The Columbia Architectural Design Review Team will meet on Tuesday, September 12, 2023 at 9:00 AM in Conference Room A on the basement level of City Hall, 700 N. Garden Street to consider the following:

PROJECT DESCRIPTION: Arden Village Retail

PLANNING STAFF EVALUATION:

Sheet Name
EXTERIOR
ELEVATIONS

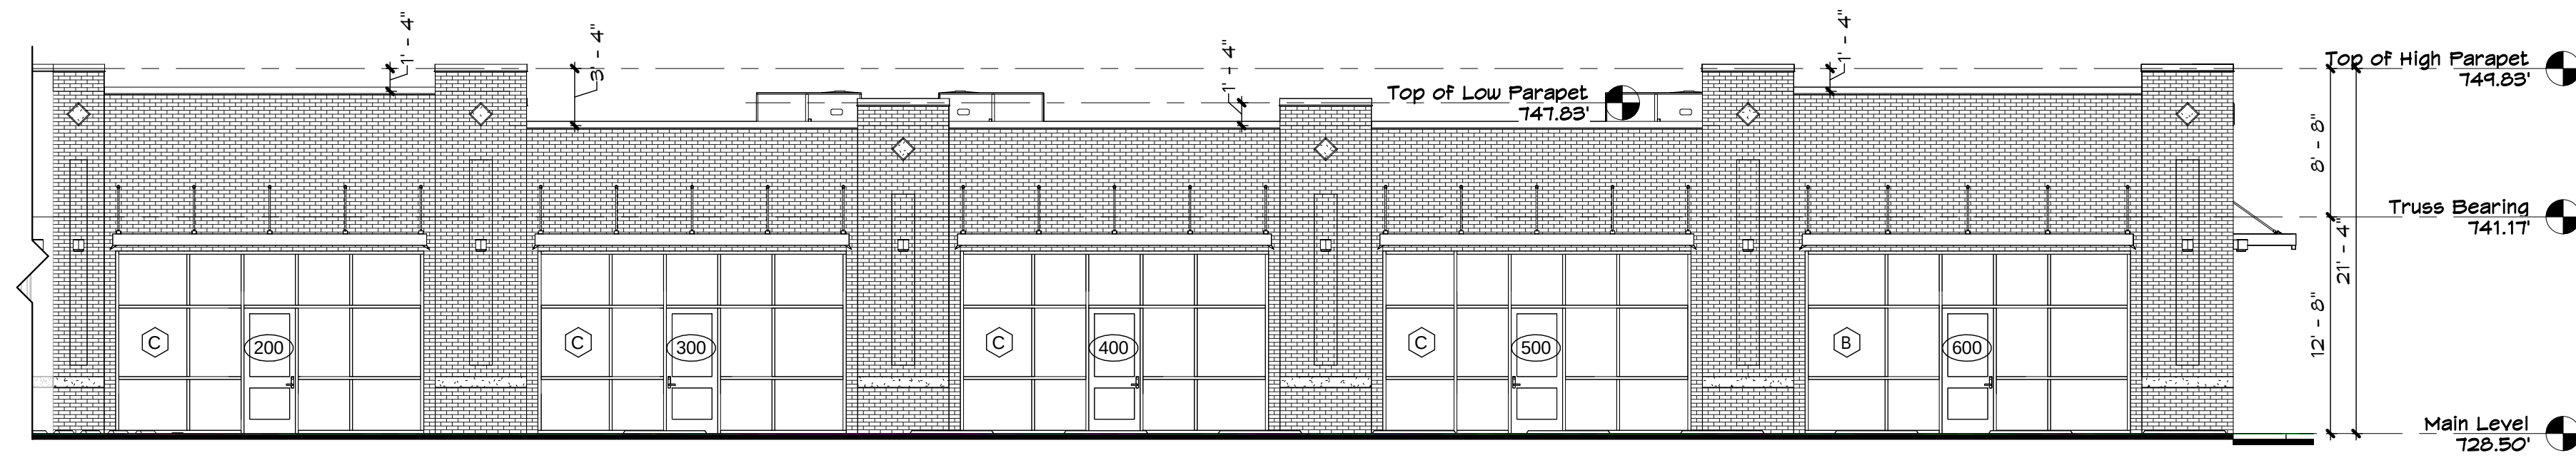
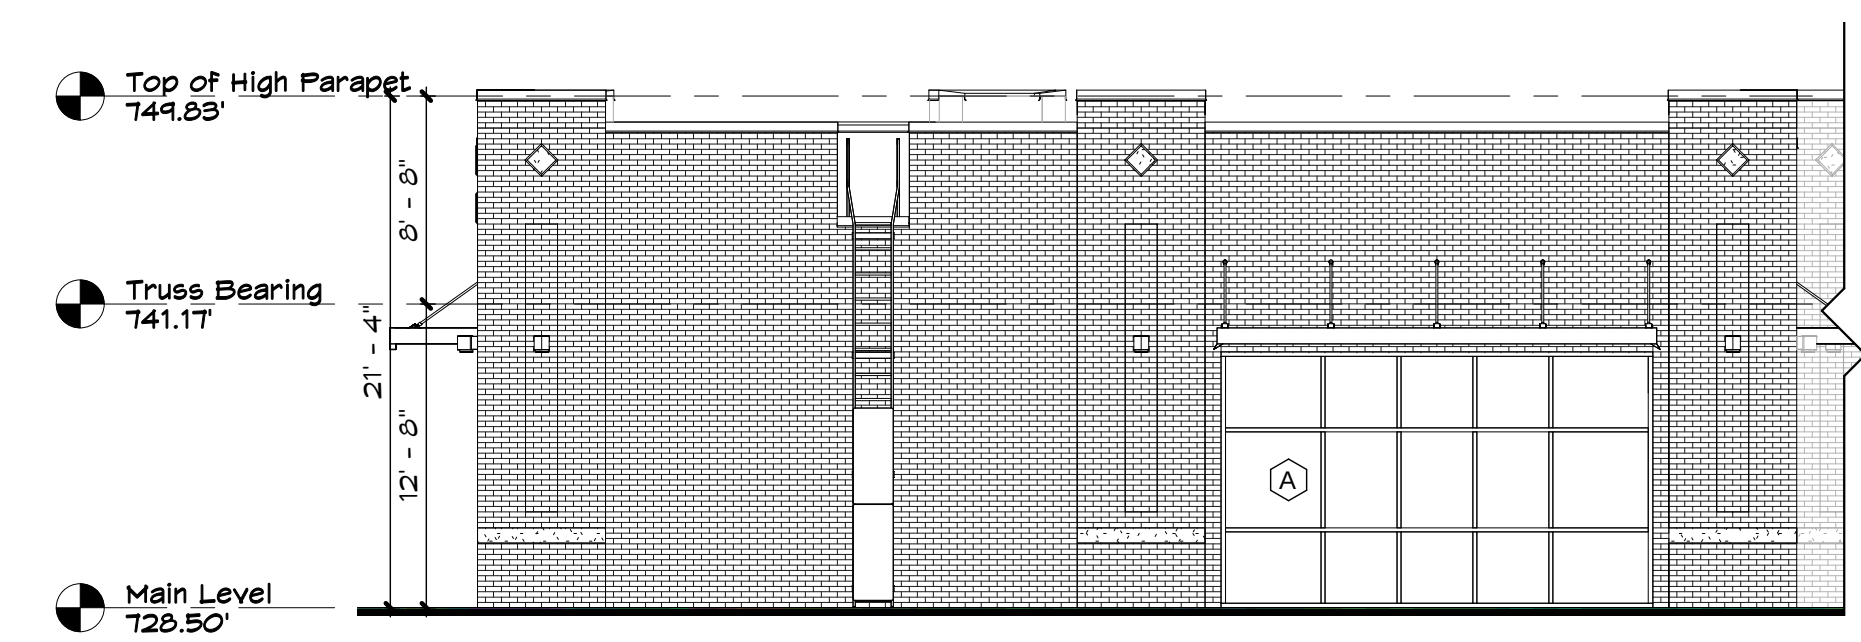
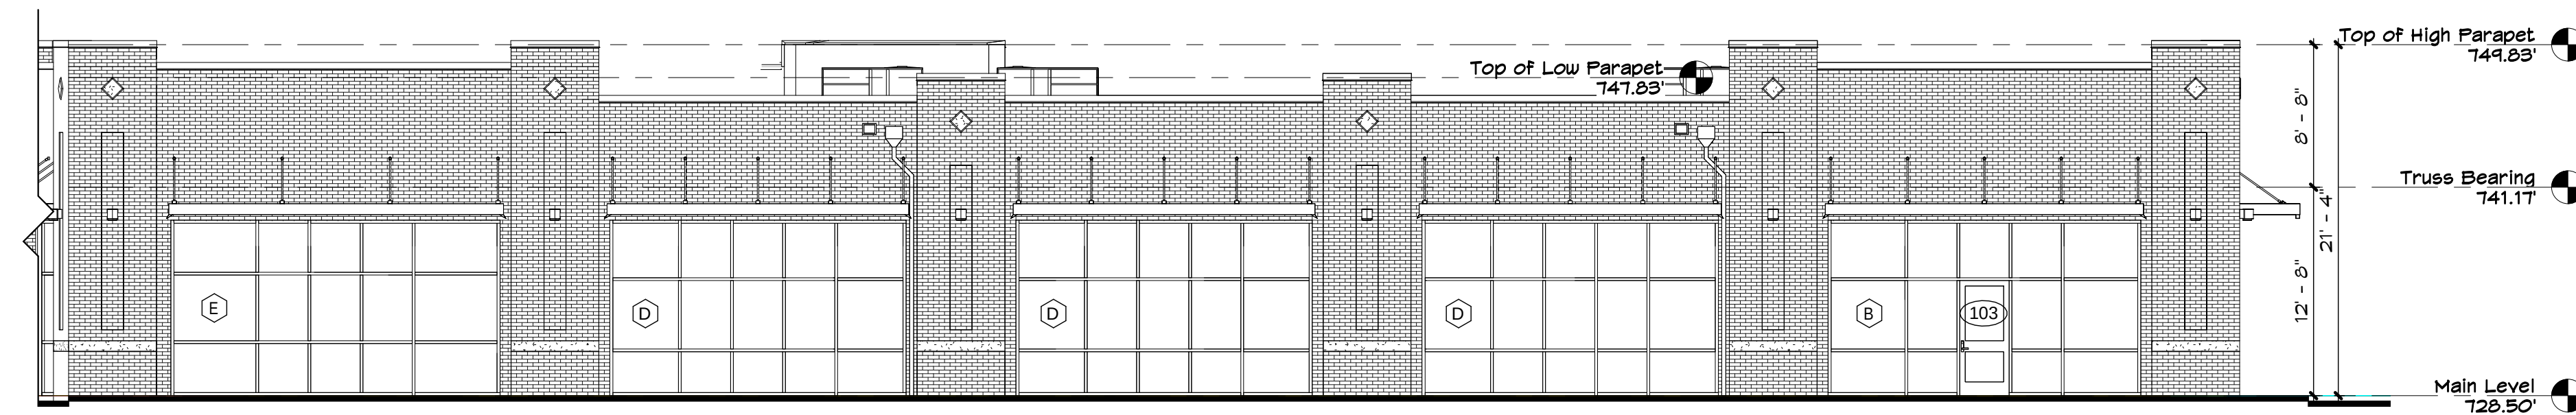
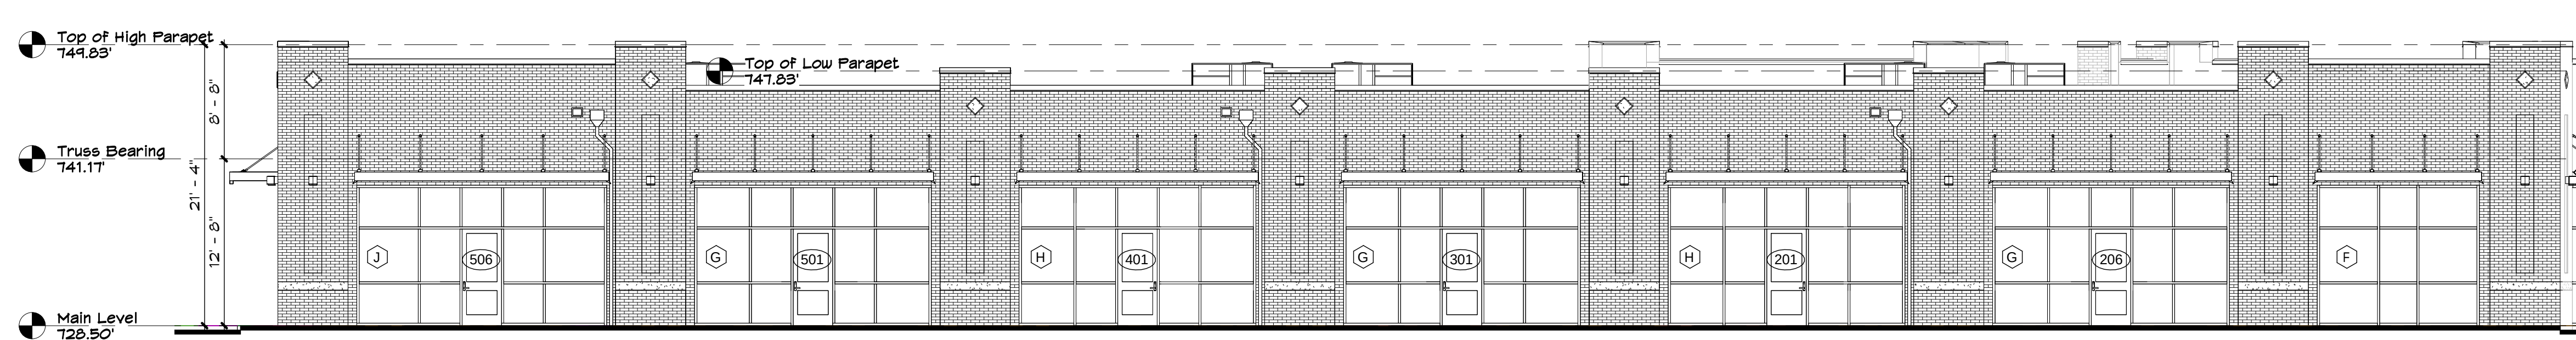
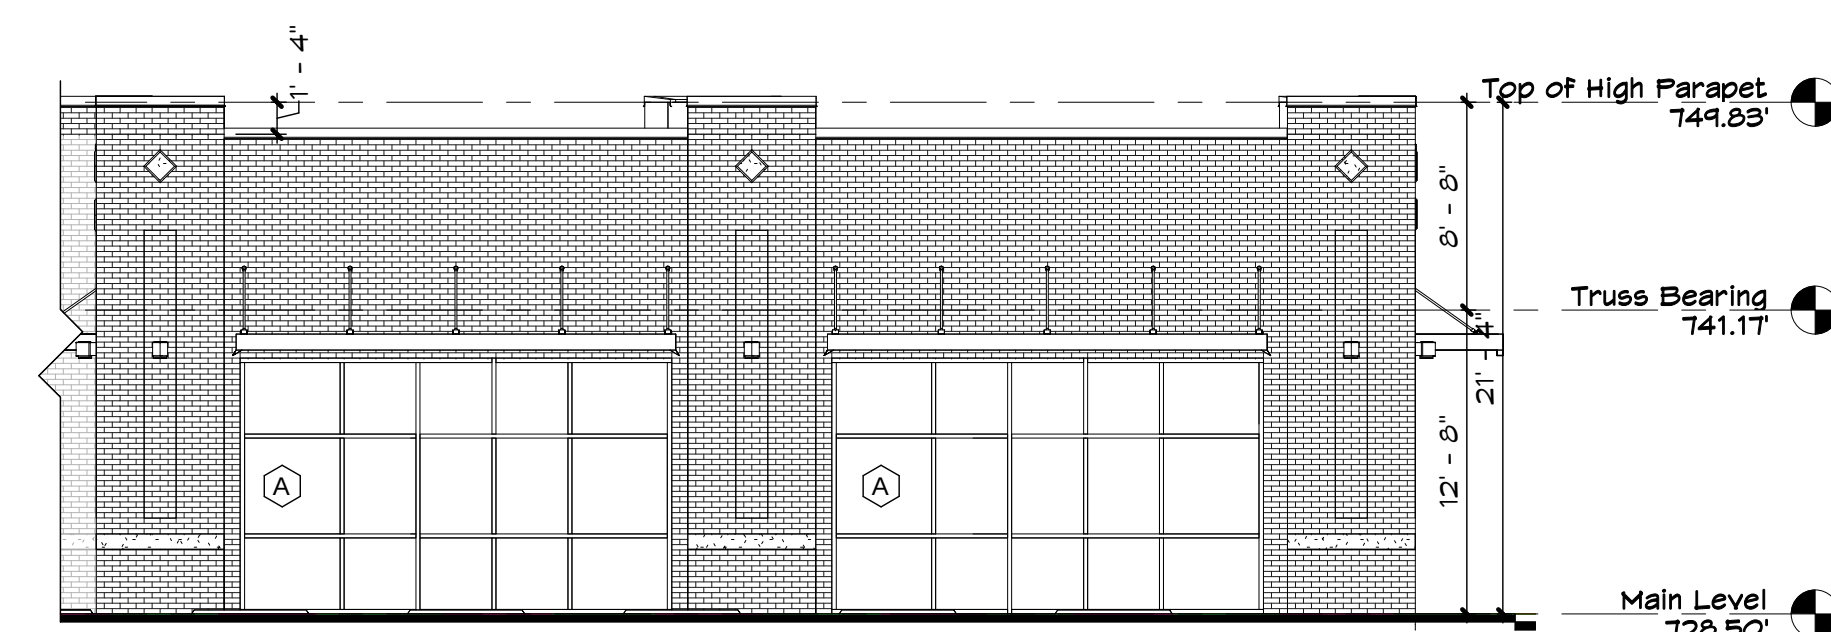
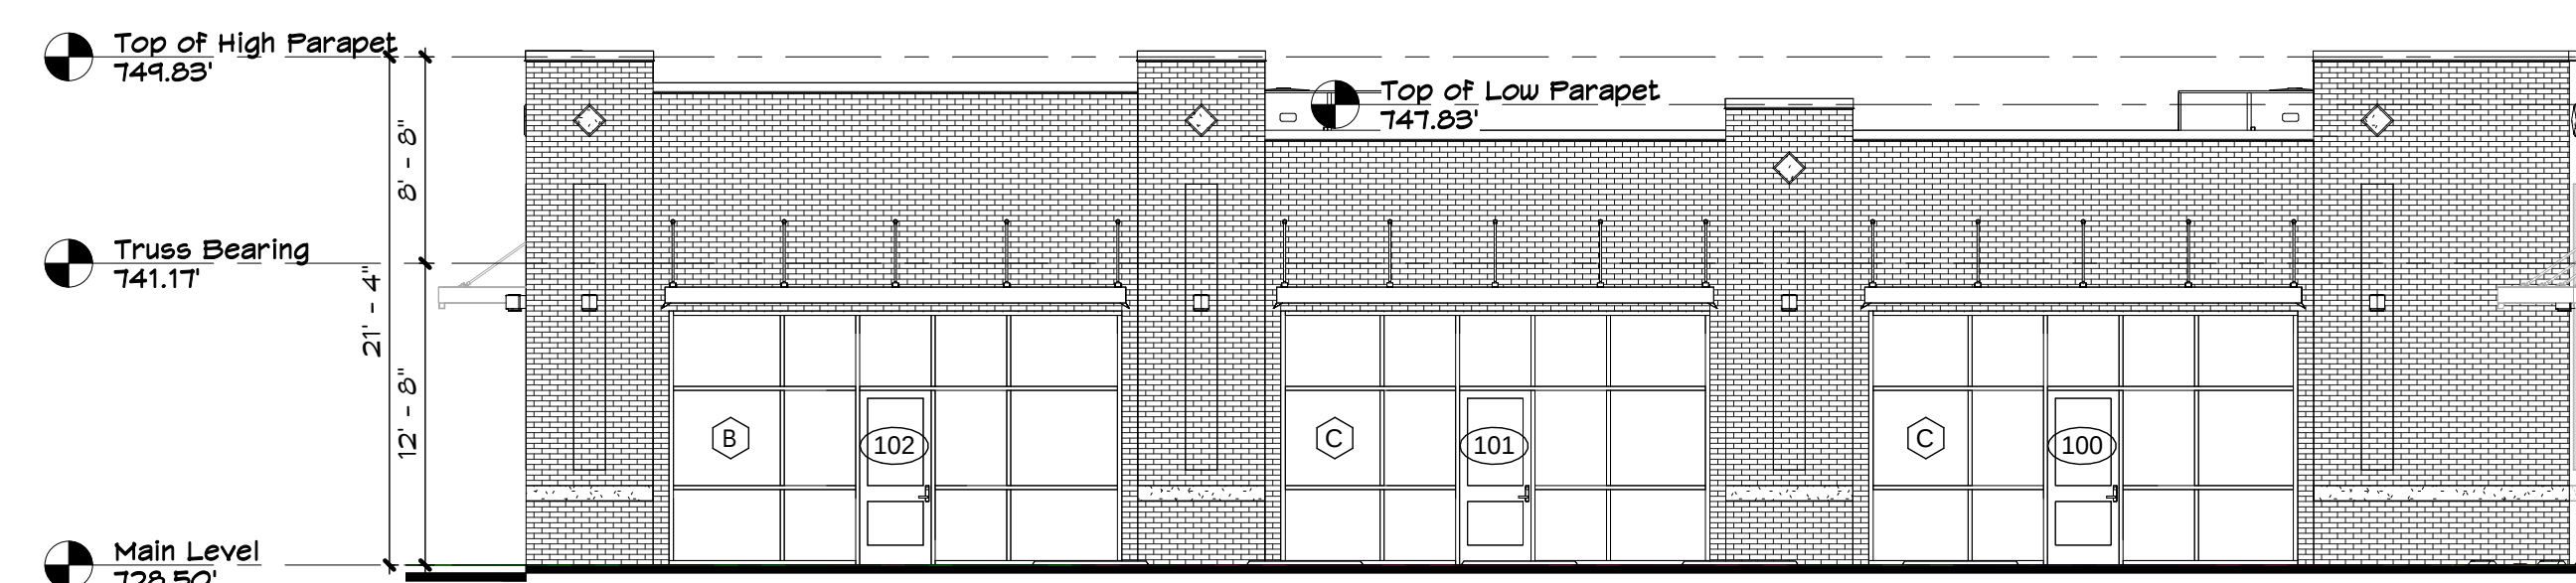
- The Ordinance requires a ceiling height of 11 feet. The design appears to provide this ceiling height.
- The PUD-MU standards require 70% for Shopfront frontages (20% - 60% for other frontage types). The proposed building does not meet this requirement.

Staff recommends that the Architectural Design Review team discuss the proposal with the applicant's representative in order to better understand how the project will comply with the PUD-MU standards. It is appropriate to defer action on the request and allow the applicant to revise the design before it proceeds to the Planning Commission.

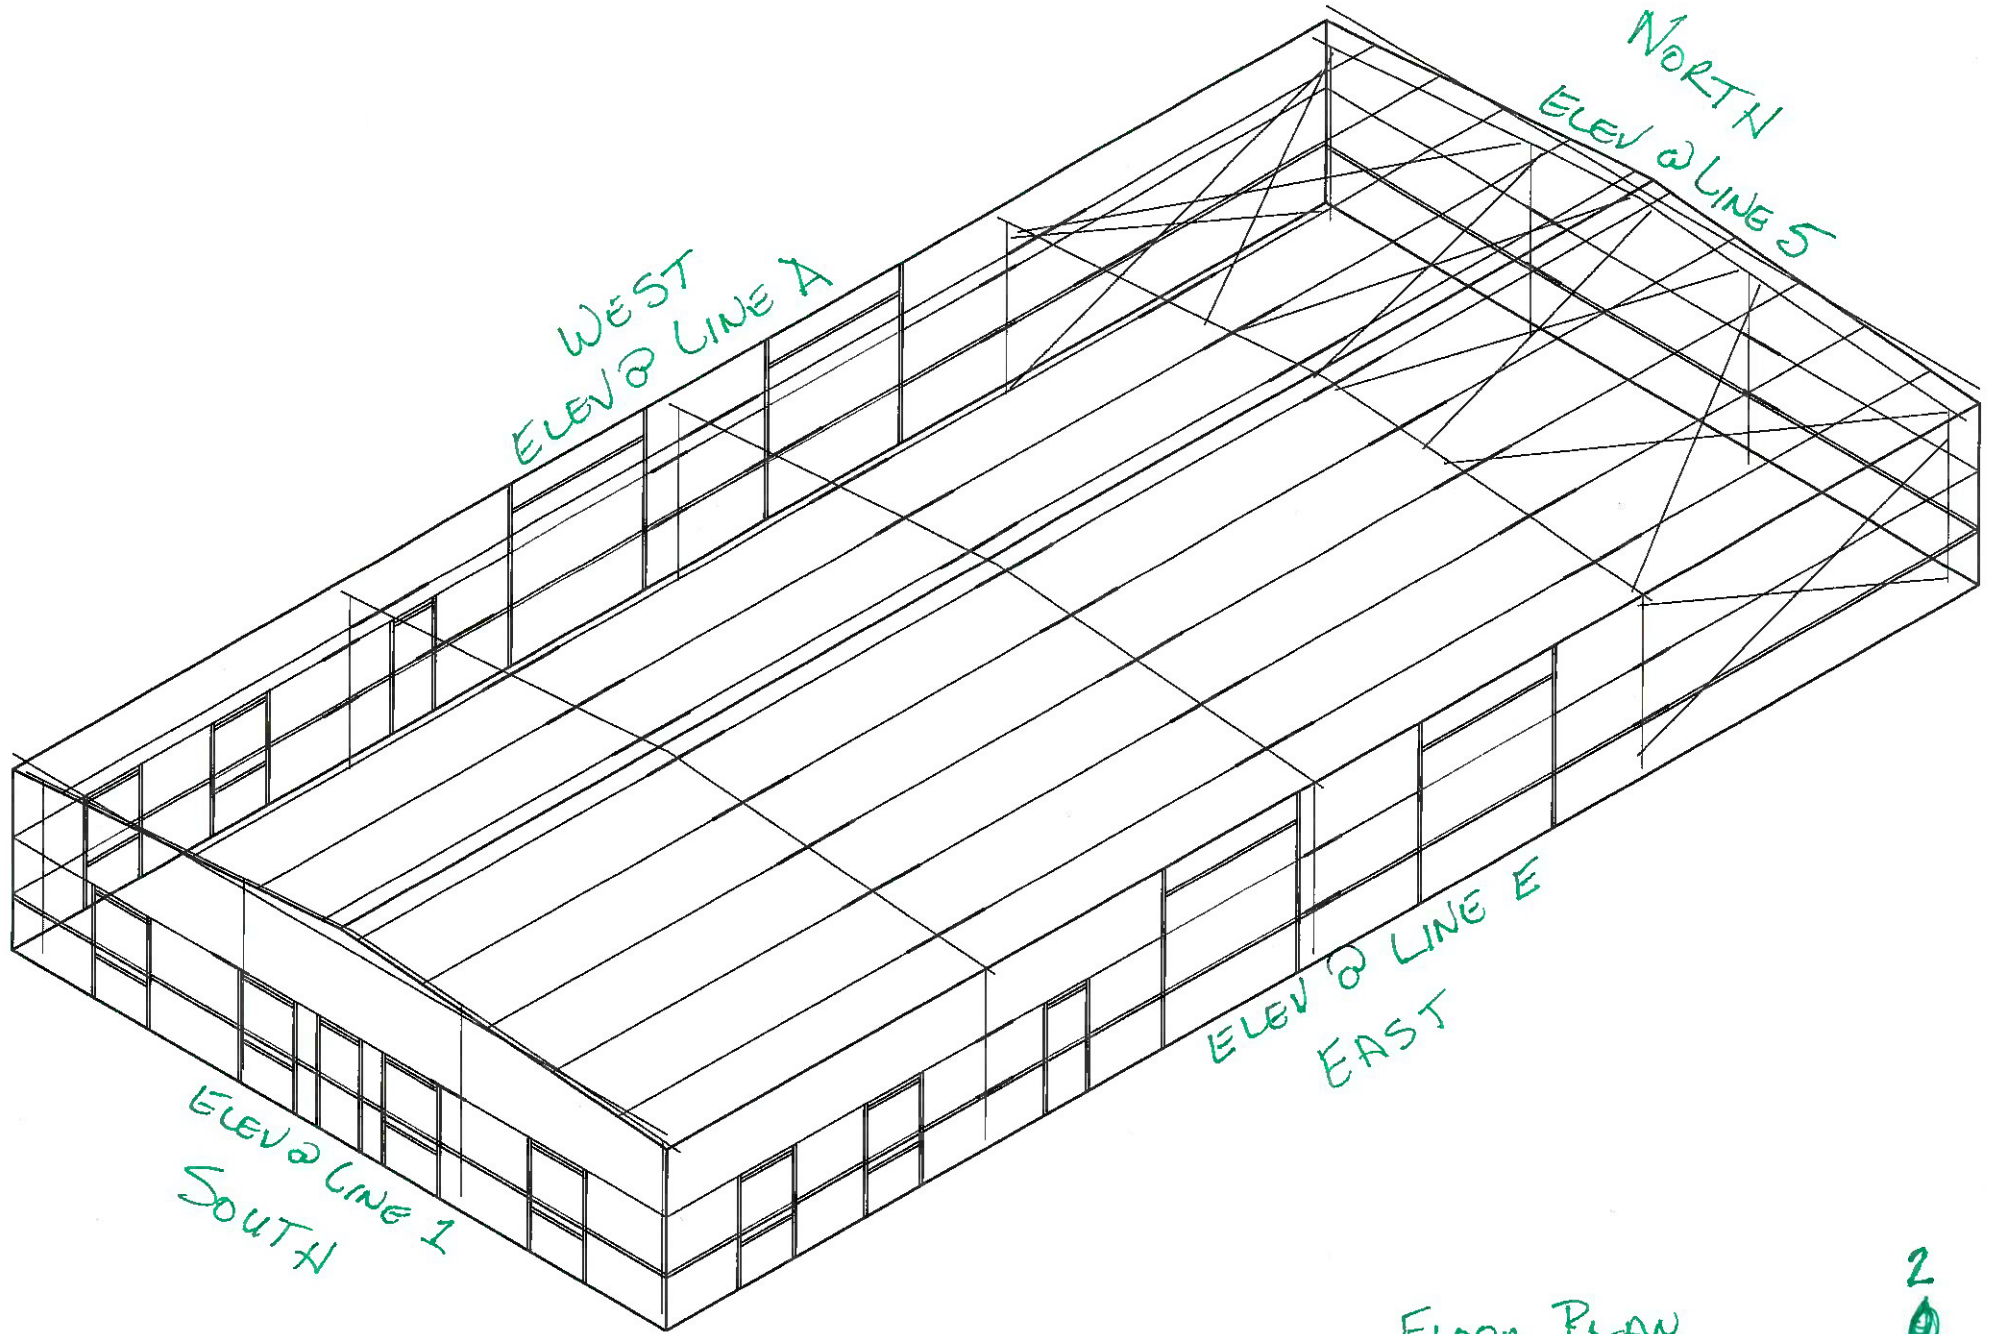
Overall façade material will consist of a corrugated metal building that complies with the building façade standards as described for structures in an SD LI zone.
